Hydrologic Evaluation of Proposed Hermosa Mine Water Treatment Plant (WTP2) Discharge

Presentation to PARA
November 12, 2020

Patagonia Area
Resource Alliance

Figure 11 – Extent of Calculated PMA in Harshaw Creek (yellow) Resulting from Maximum 4,500 gpm Discharge from WTP2

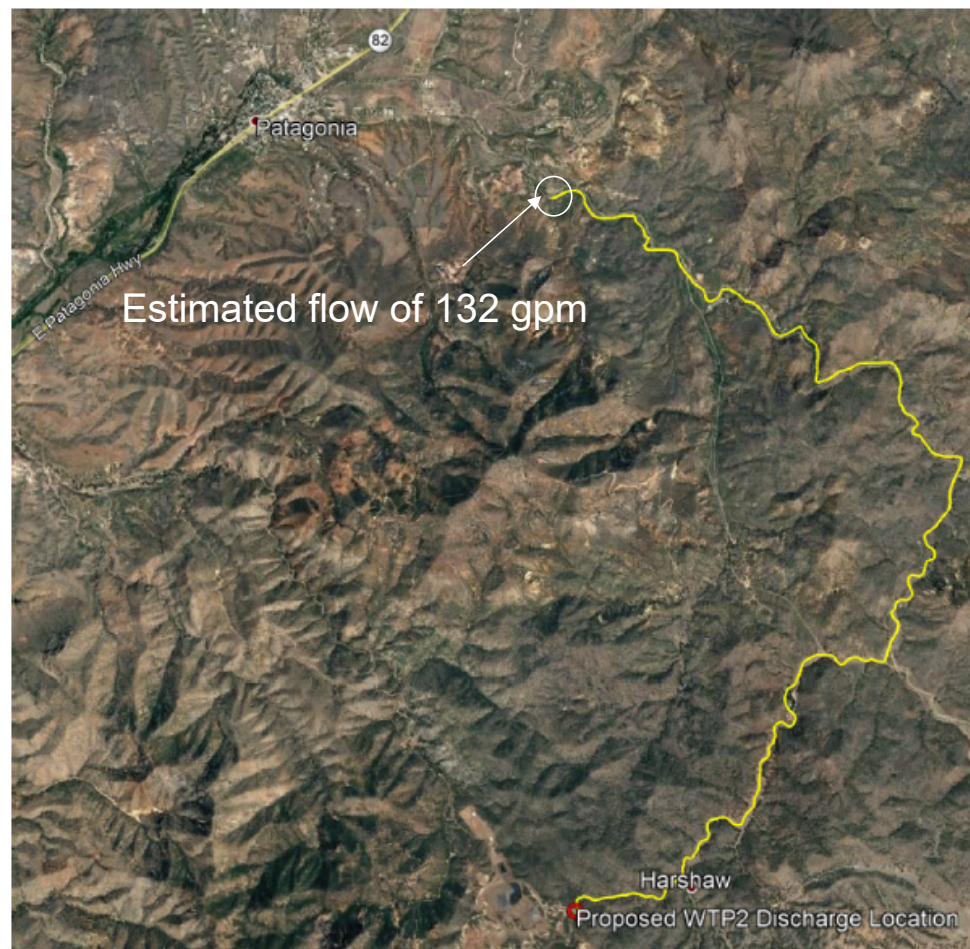
- Shows no/minimal impacts on Sonoita Creek
- Simulated Groundwater rise ~3 miles across Harshaw Cr:
 - MIKESHE shows impact along Harshaw Cr. limited to channel alluvium and bedrock just around creek (hundreds of feet – not 3 miles)
- “Steady State” analysis doesn’t account for effects of subsurface saturation and storm events on streamflow.

Area of Groundwater Rise extends nearly **3 miles** around Harshaw Creek - Unrealistic

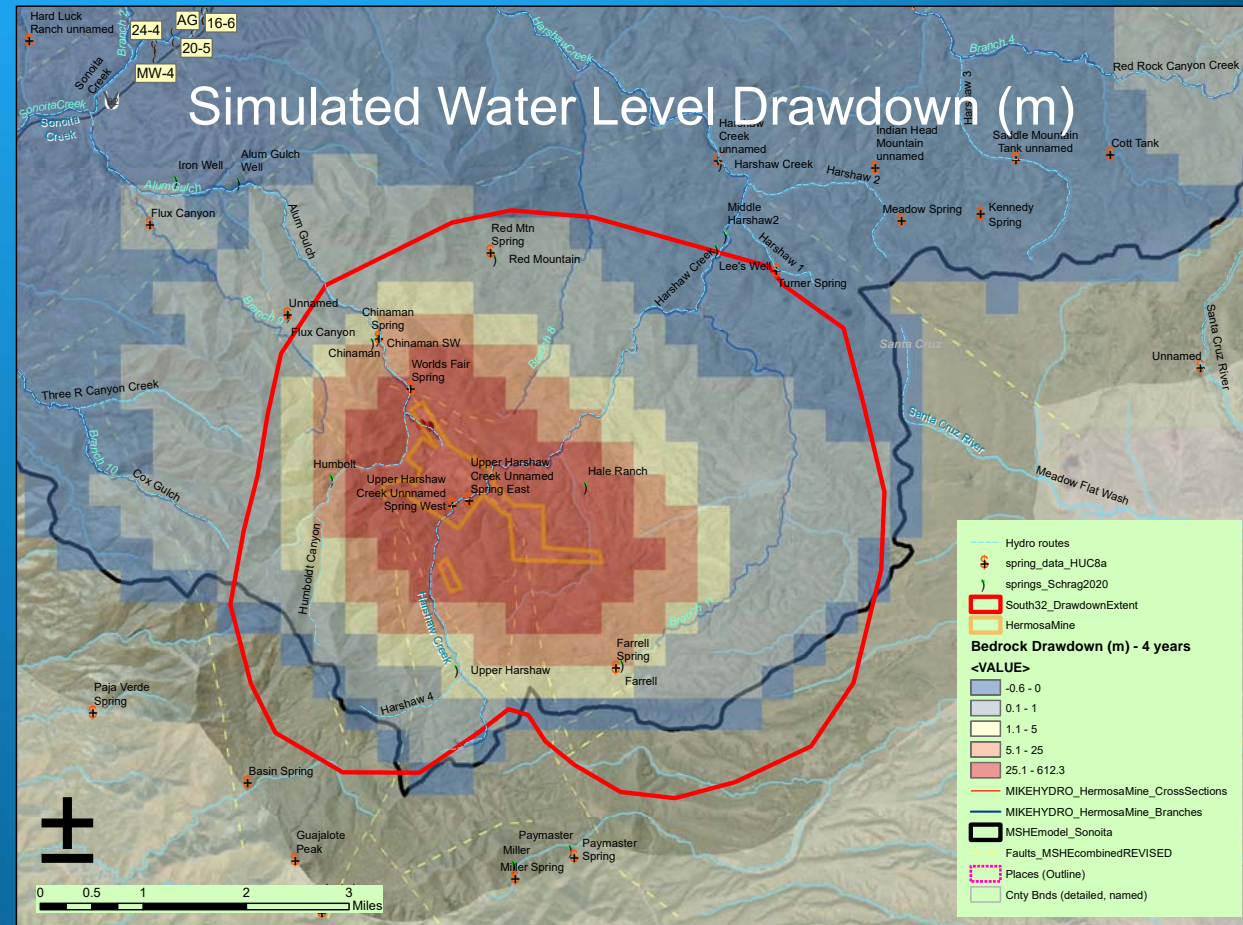
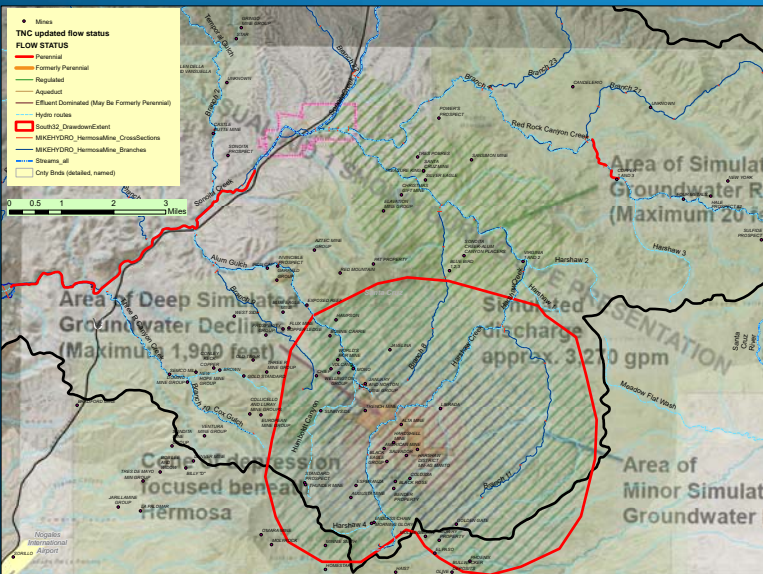
South32 Groundwater Model
(purple line) only includes
Harshaw Creek → **can't assess
impacts to Sonoita Cr upstream.**

Model boundary clearly affects both drawdown (red line) and groundwater mounding (green line).
